Reference: Division of Facilities Construction and Management
New North Ogden Liquor Store and Demolition And Replacement Of The
Ogden (Patterson Avenue) Liquor Store
DFCM Project Nos. 04242030 and 04180030

Subject: **Addendum No. 4**

Addendum No. A04

**New Harrisville, Ut Liquor Store
Department of Alcoholic Beverage Control
433 North Main Street, Tooele, Utah
DFCM Project No. 04242030**

ADD-1

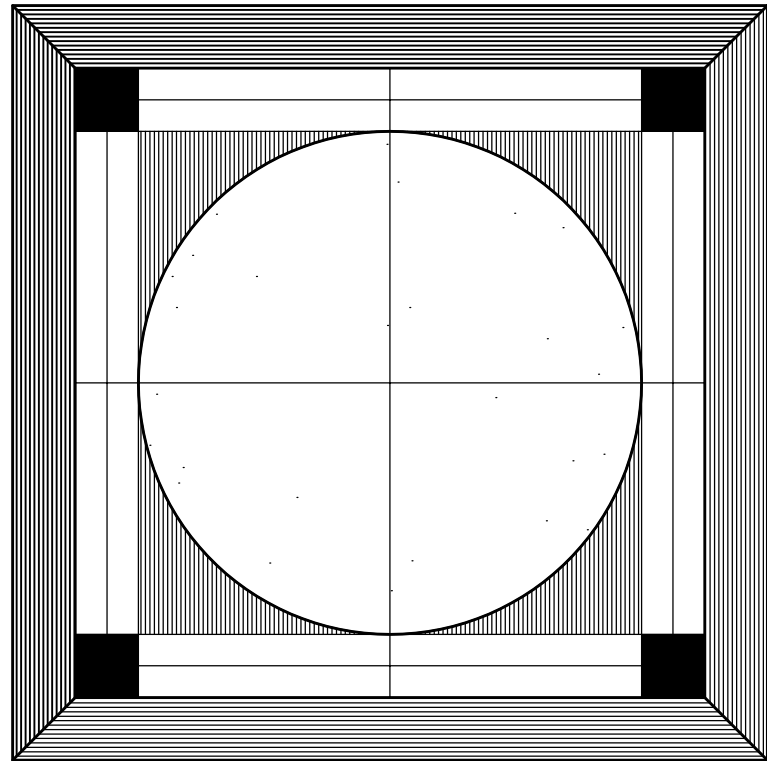
Drawing ADD-1 (new):

1. Drawing, ADD-1, showing the profile and a section of the employee entrance ramp at the rear of the building, has been included.

ADD-2

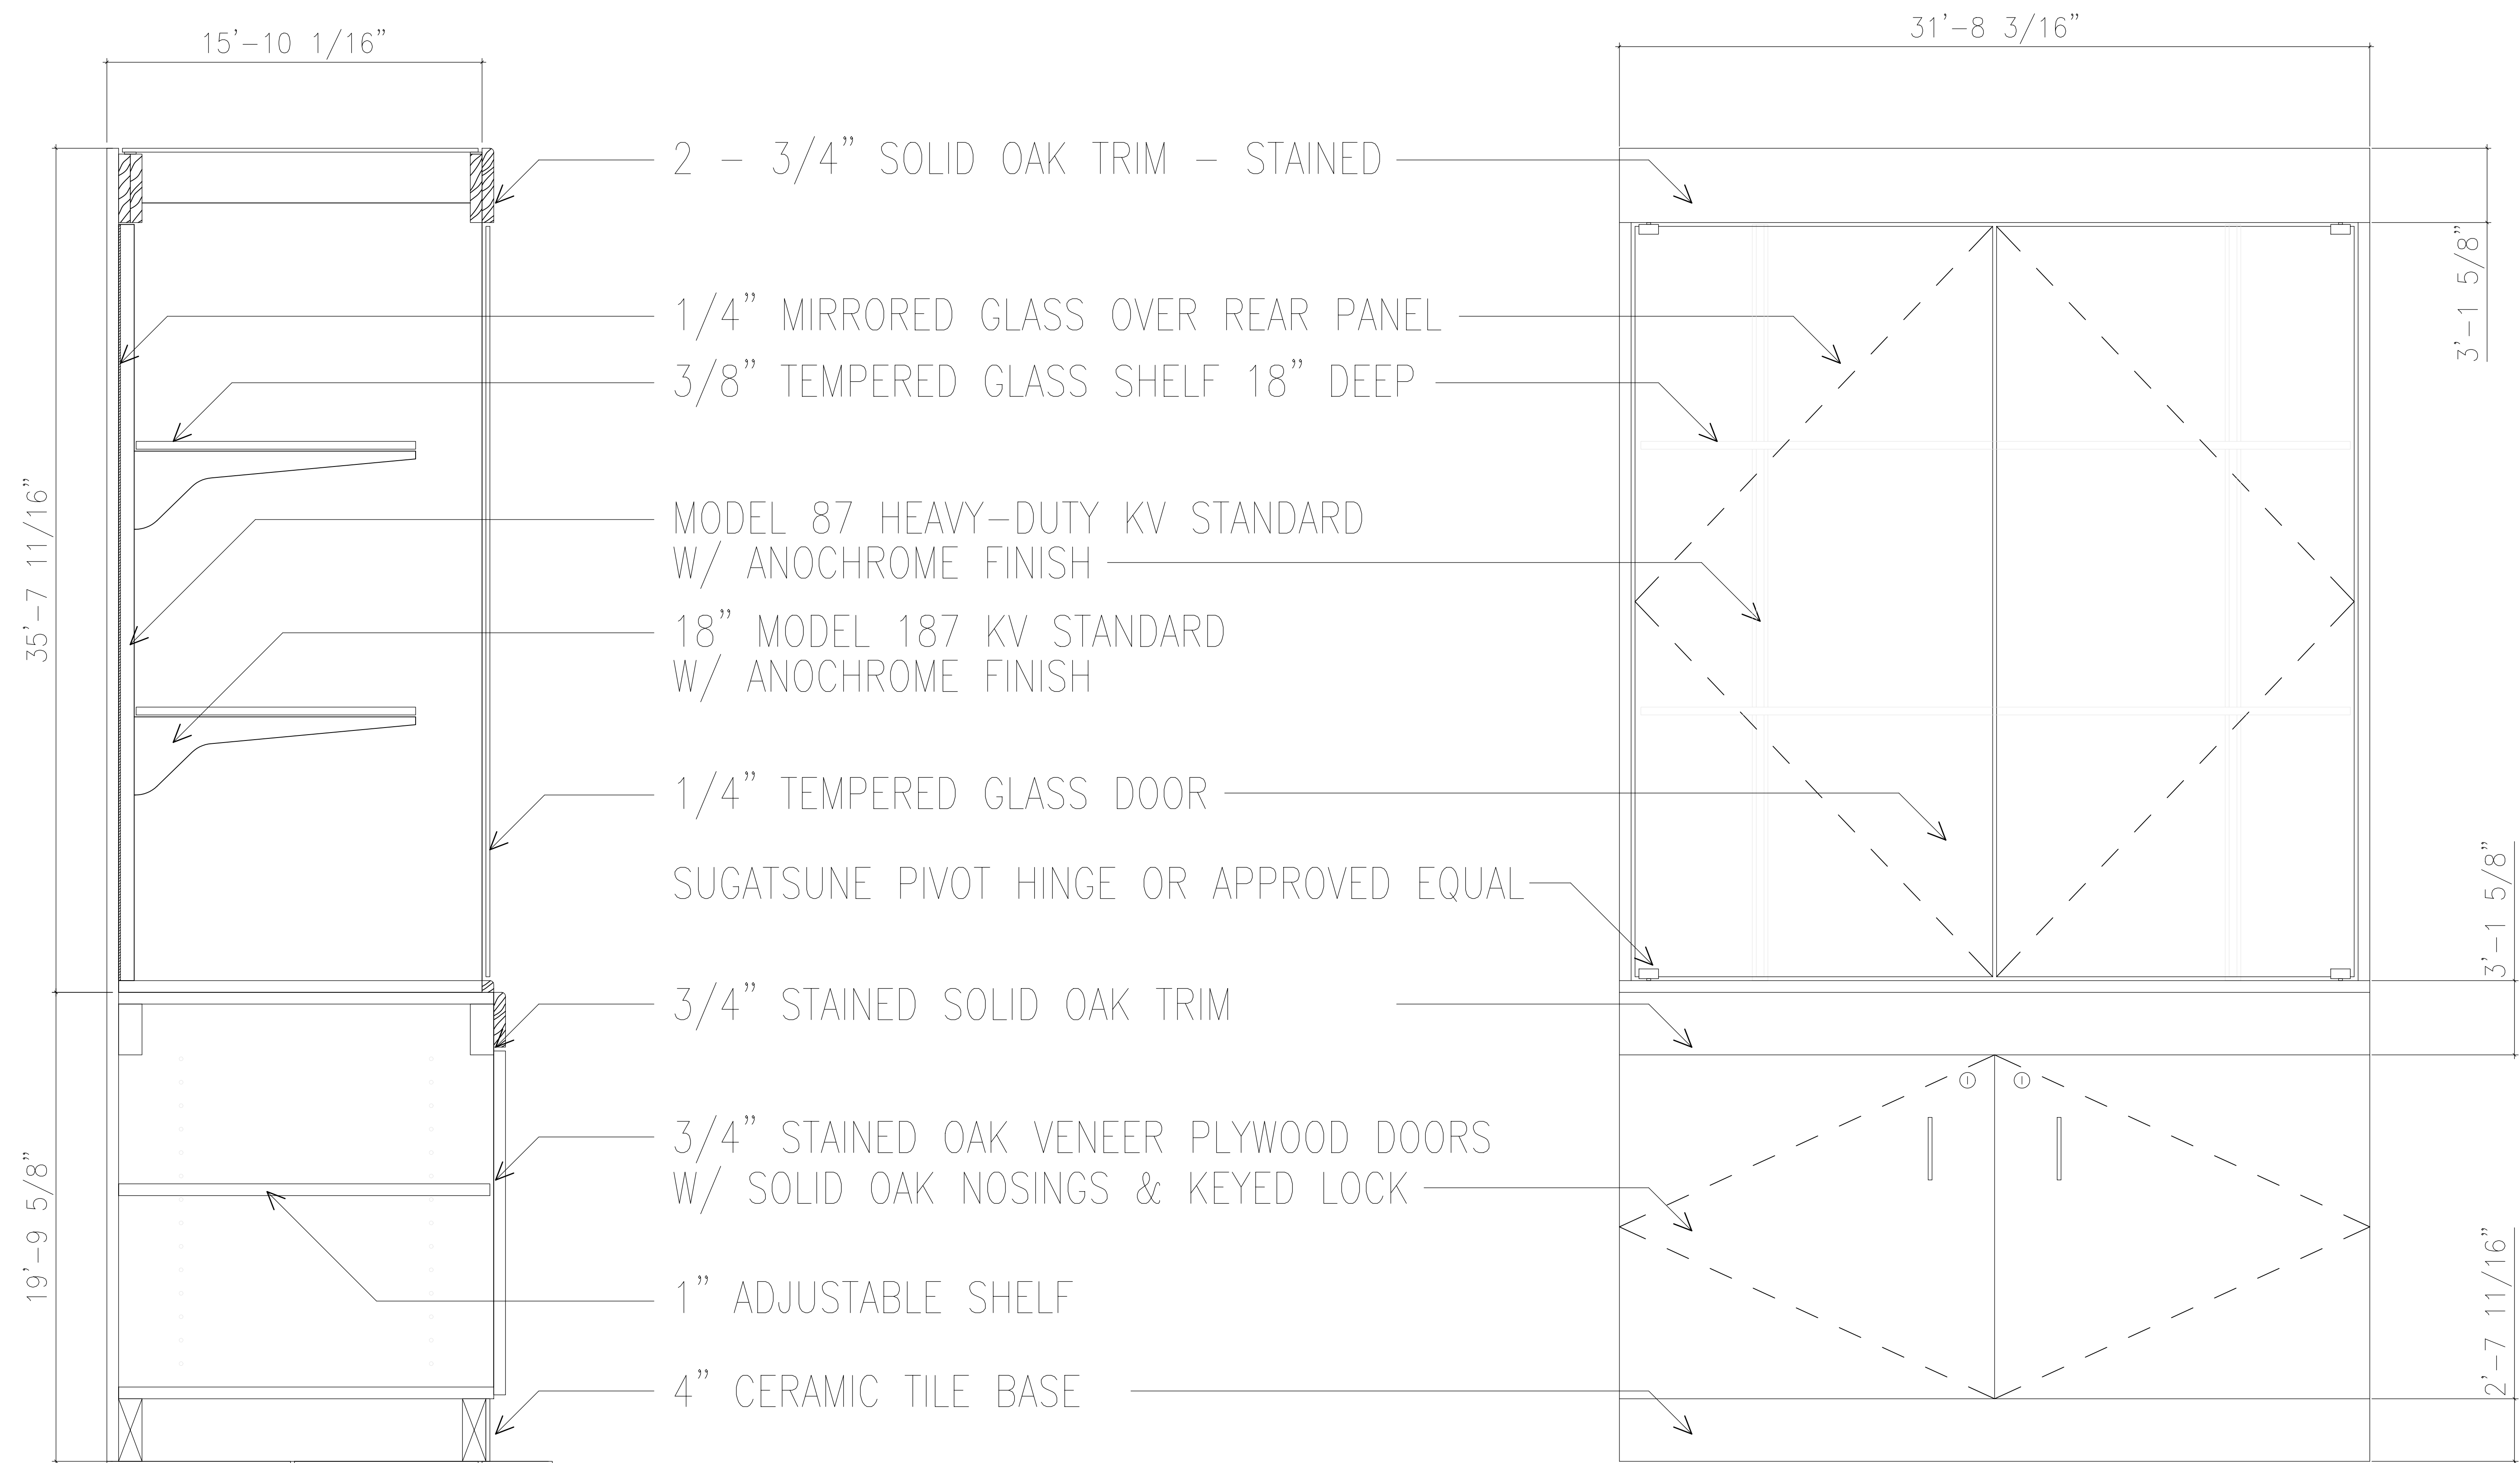
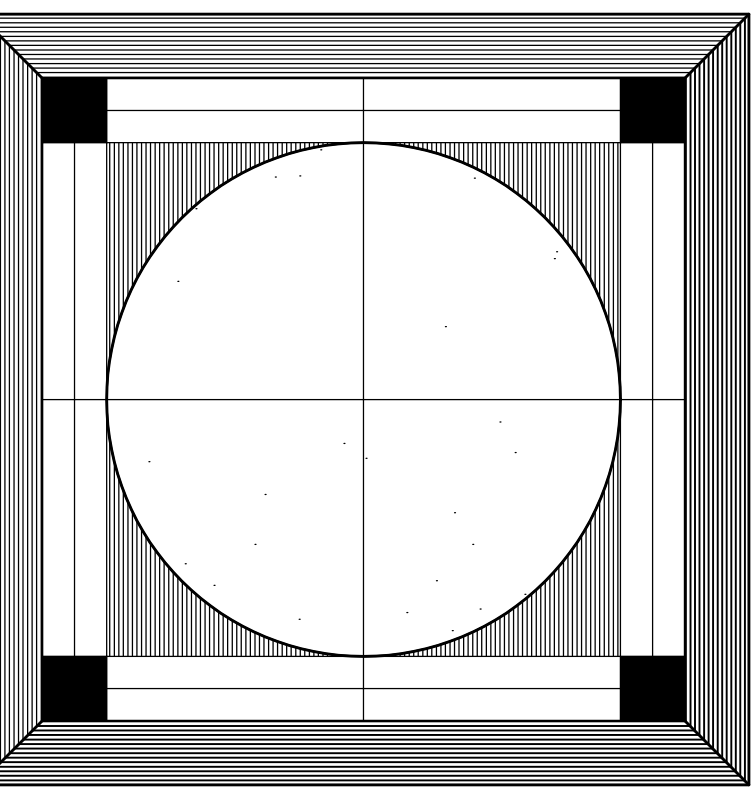
Drawing ADD-2 (new):

1. Drawing ADD-2, detailing the three (3) contractor-furnished display cabinets, has been included.

AS
102

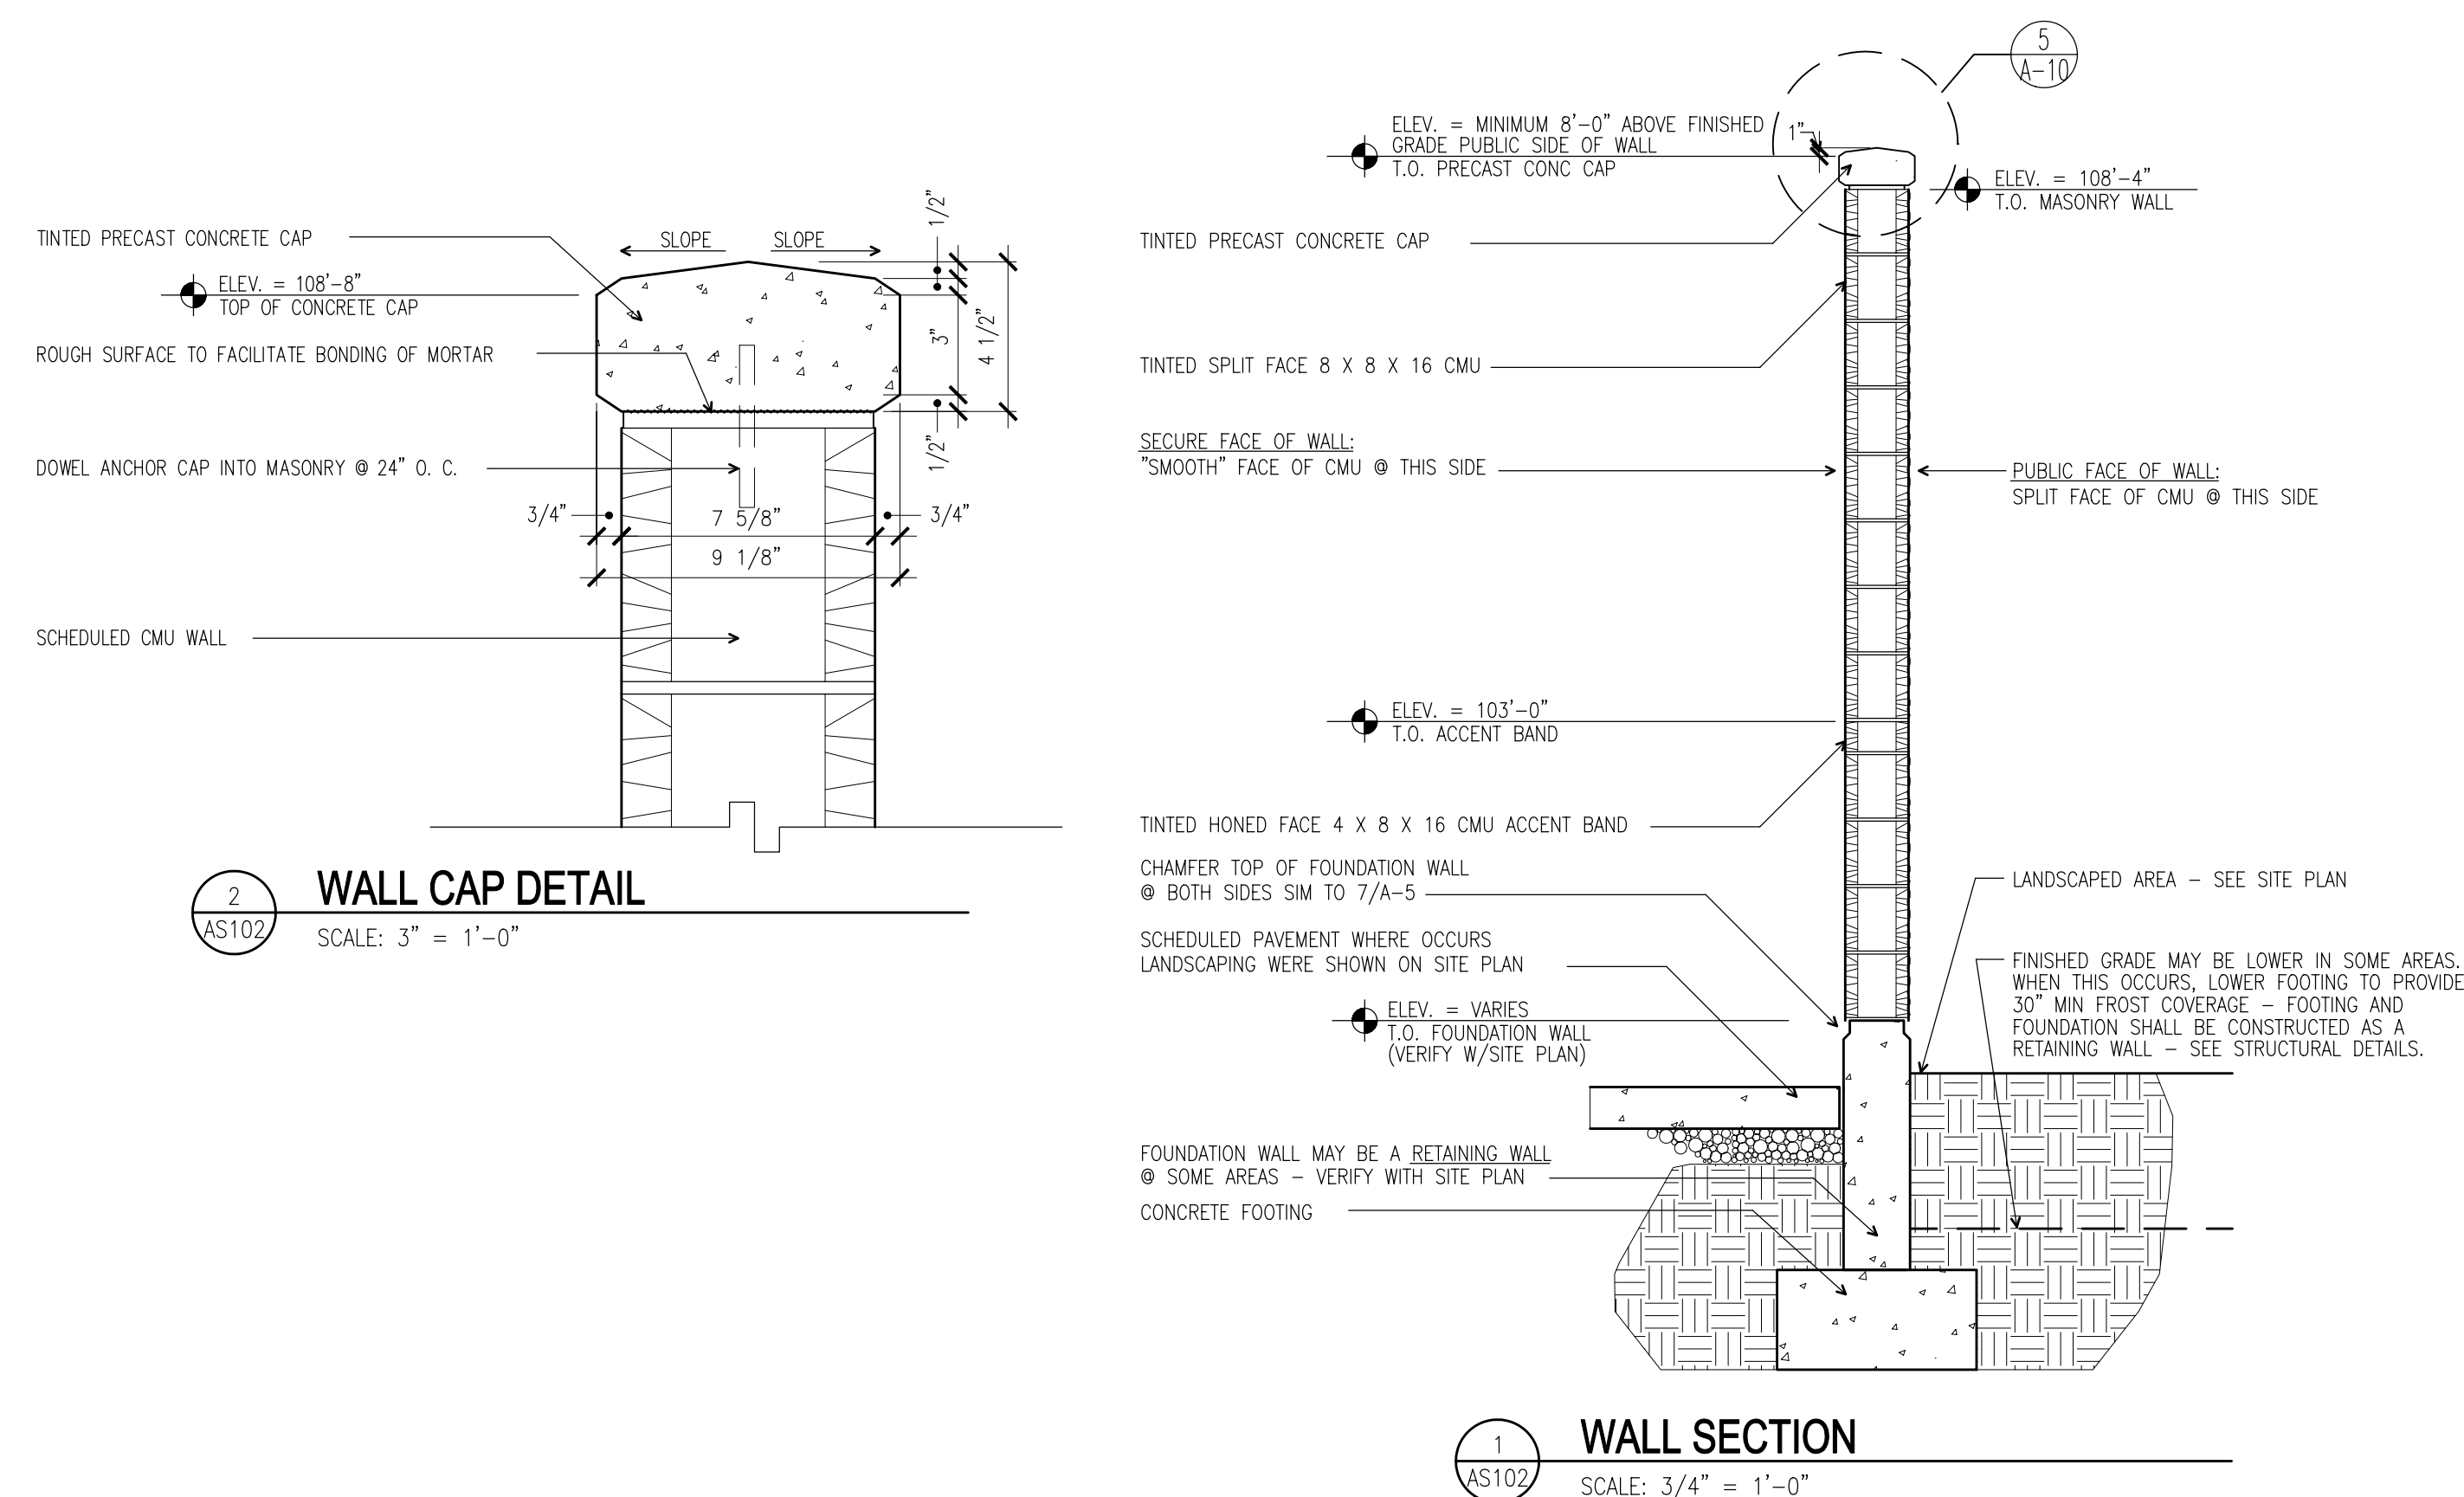
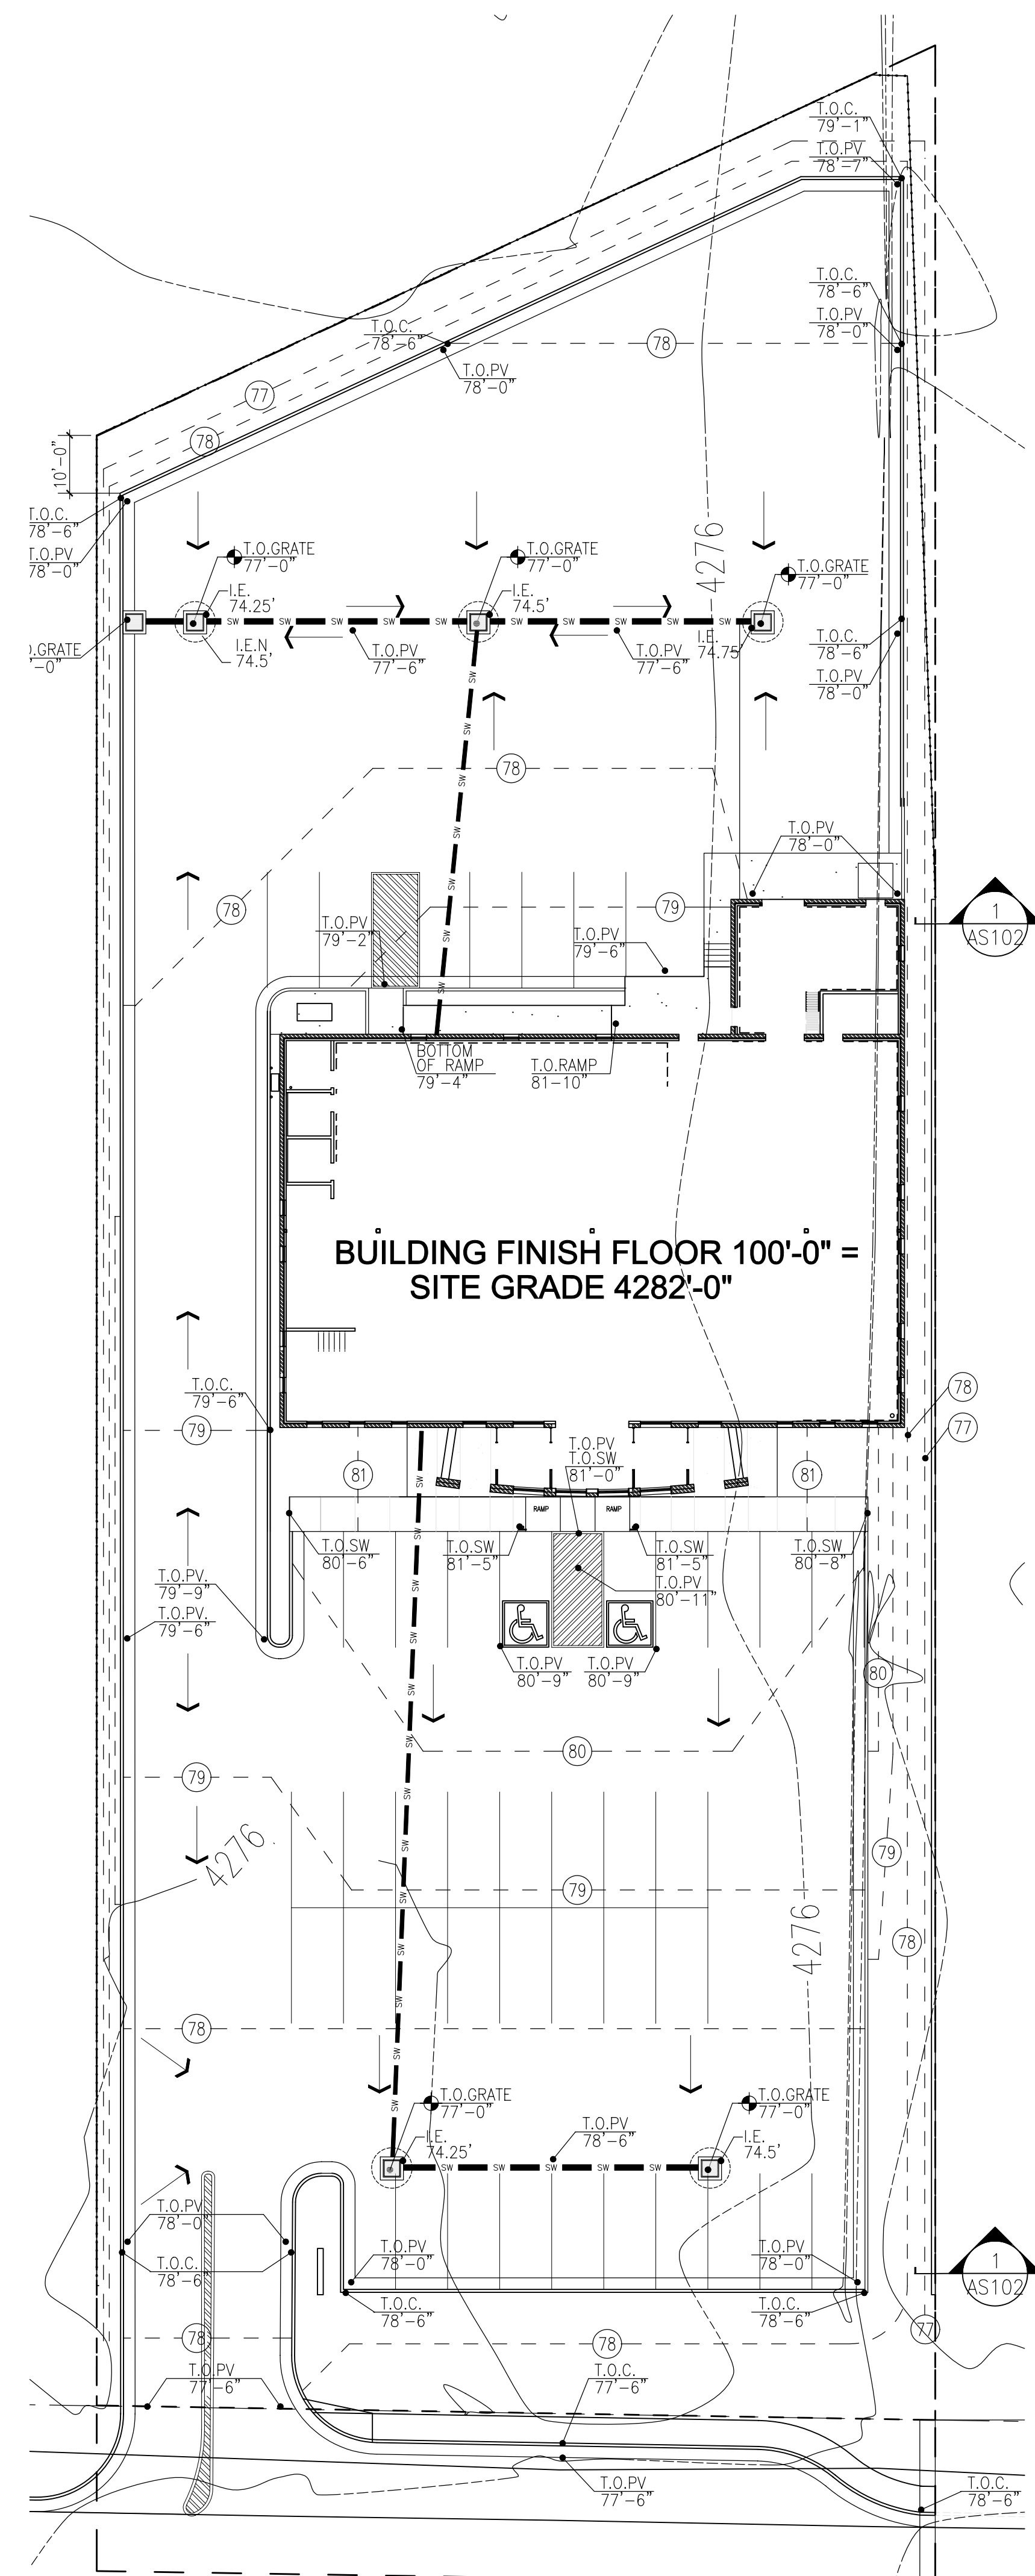
Drawing AS102 has been re-issued with the following change:

- 1.1 The north arrow has been rotated and clouded to reflect the correct orientation of the building and the site.

REVISION
	THE NORTH ARROW HAS BEEN ROTATED TO REFLECT THE CORRECT ORIENTATION OF THE BUILDING AND THE SITE.
